MEMORANDUM

SUBJECT: Wheaton Mixed Use Development Review
SWA Project No. 12-10.18

DATE: July 28, 2015

Figure 1: Georgia Avenue at Reedie Drive with optional westbound shared LTR lane.

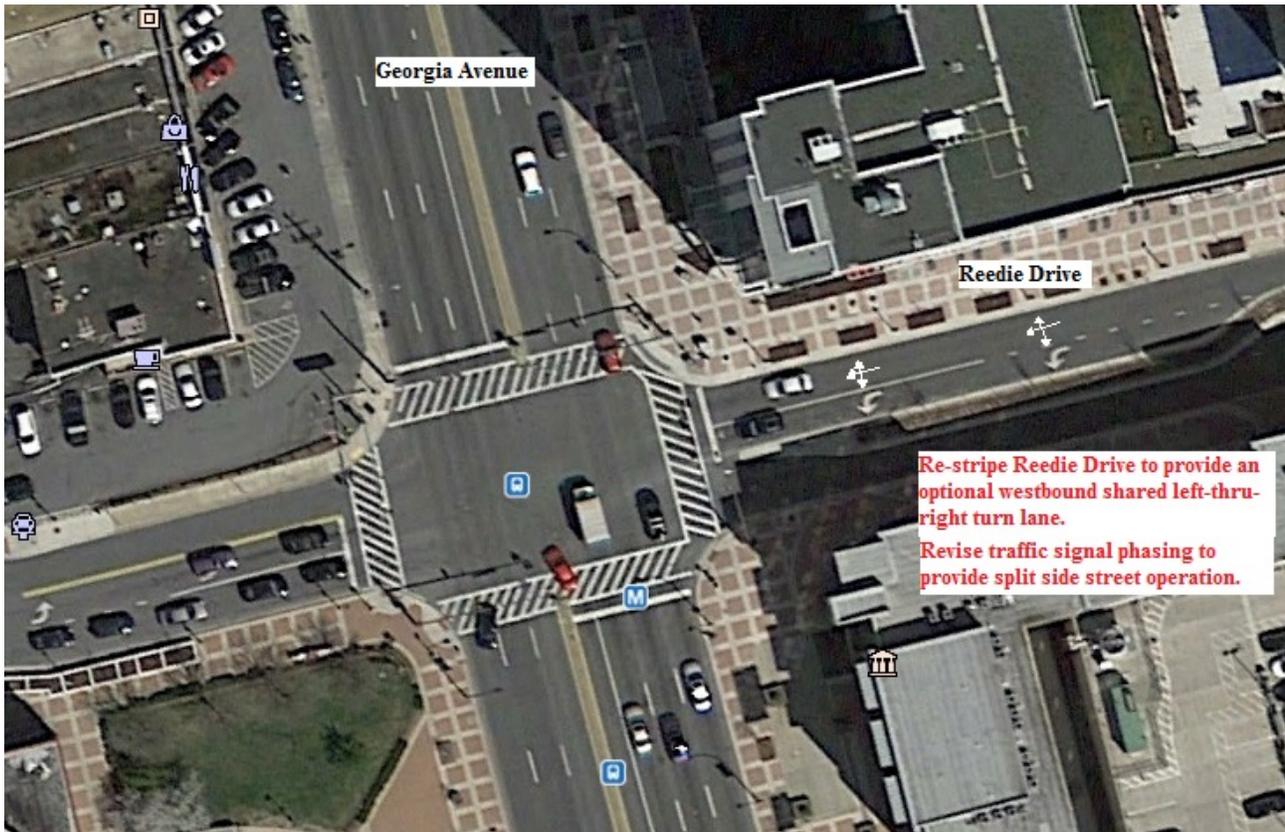
Under the Reedie Drive One-way Option, additional westbound left turn demand would be created at the intersection of Georgia Avenue/Reedie Drive. The westbound left turn storage bay at this location is only 150 feet in length, and would experience left turn "spill back", potentially blocking Reedie Drive. An option to split the side street movements at this location and create an optional westbound double left turn movement was evaluated (**Figure 1**). This intersection currently operates at acceptable Synchro LOS C or better, and would continue to do so even with split side street phasing. Level-of-service calculated using the critical lane analysis technique show this intersection is currently operating at LOS "A", and would remain at LOS "A" even with split side street phasing.

Figure 2: Veirs Mill Road at Wheaton Plaza South/Metro Entrance - proposed channelization - northbound left turn bay.

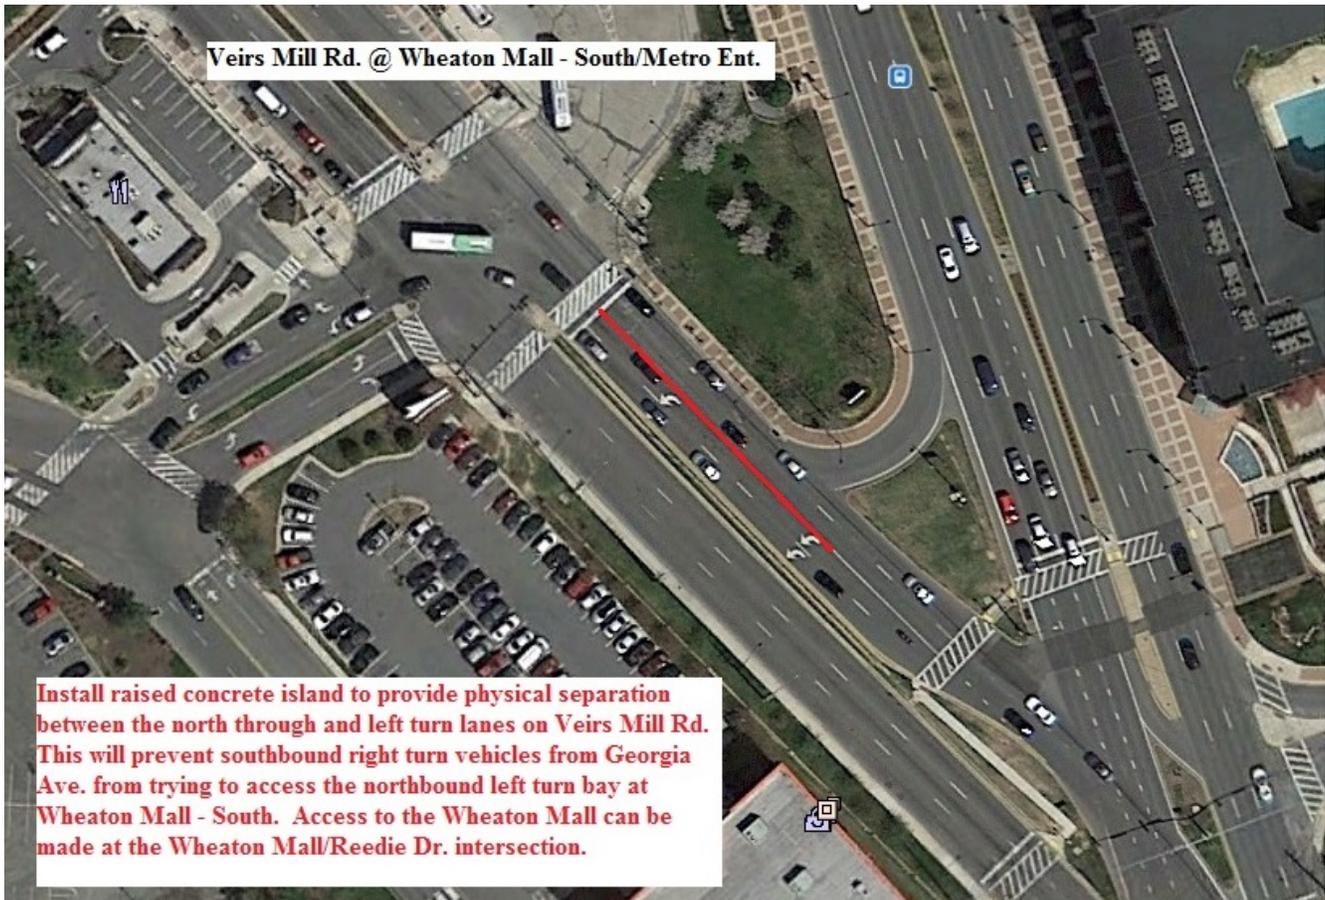
Due to the close proximity of the traffic signals at Georgia Avenue/Veirs Mill Road and Veirs Mill Road/Wheaton Plaza South Entrance, and the skew of the two roadways, the right turn access point from southbound Georgia Avenue onto northbound Veirs Mill Road enters Veirs Mill Road at

approximately the mid-point in the left turn storage bay for Wheaton Plaza South. This would create the potential for a serious weaving situation, and potential blockages to northbound Veirs Mill Road. The traffic volume projected to make this movement was re-assigned to pass through the traffic signal at Wheaton Plaza South/Metro Entrance, and access the Wheaton Plaza via the traffic signal at Wheaton Plaza North/Reedie Drive. The traffic signal timings and northbound storage bay length at this location are sufficient to accommodate the additional left turn demand. If the Reedie Drive One-way Option is selected, it is strongly recommended that a concrete median be constructed that would prevent vehicles turning right from southbound Georgia Avenue from accessing the left turn bay at the Wheaton Plaza South Entrance (**Figure 2**).
